SCCP Modifications

HEATH STEWART, GITESH BHAGWAT, ANDY GARDNER
SANTA BARBARA DESIGN CENTER

Modify VOLT_POWER_INFO Register to 16 Bits

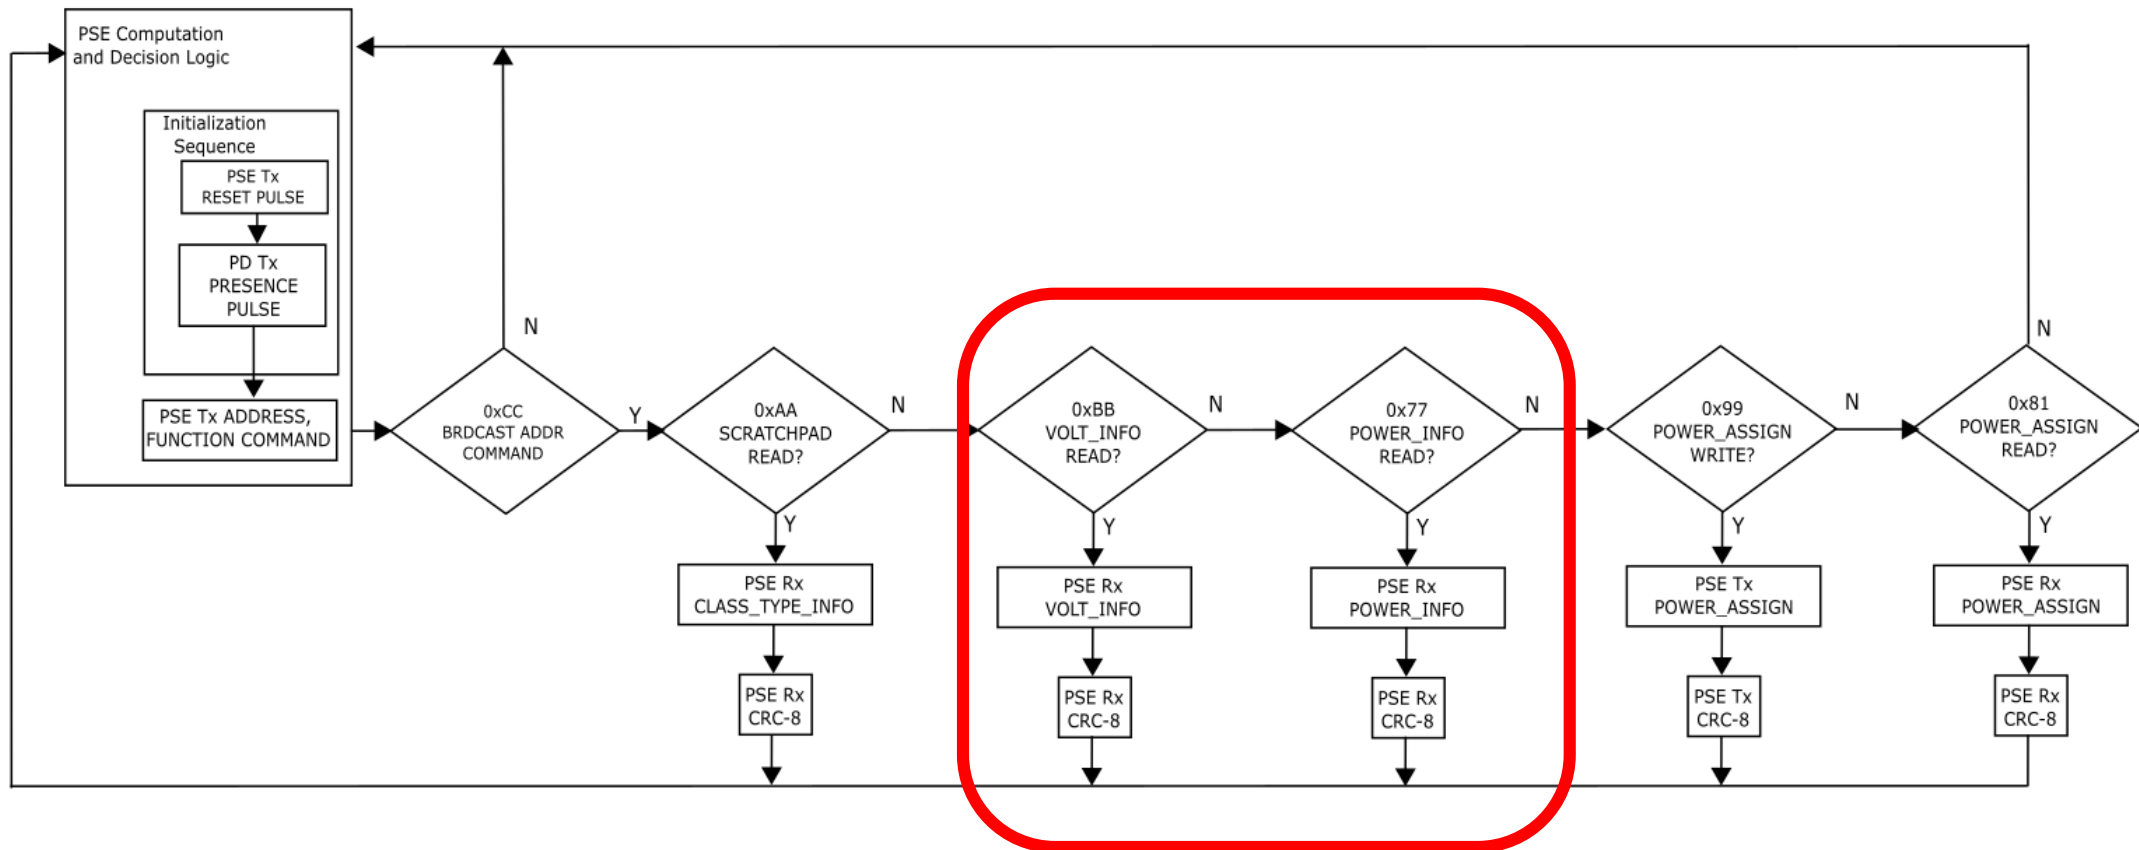
► Page 109, Line 11:

- Modify Figure 104-13 to rename the VOLT_POWER_INFO [0xBB] read command and to add the POWER_INFO [0x77] read command:
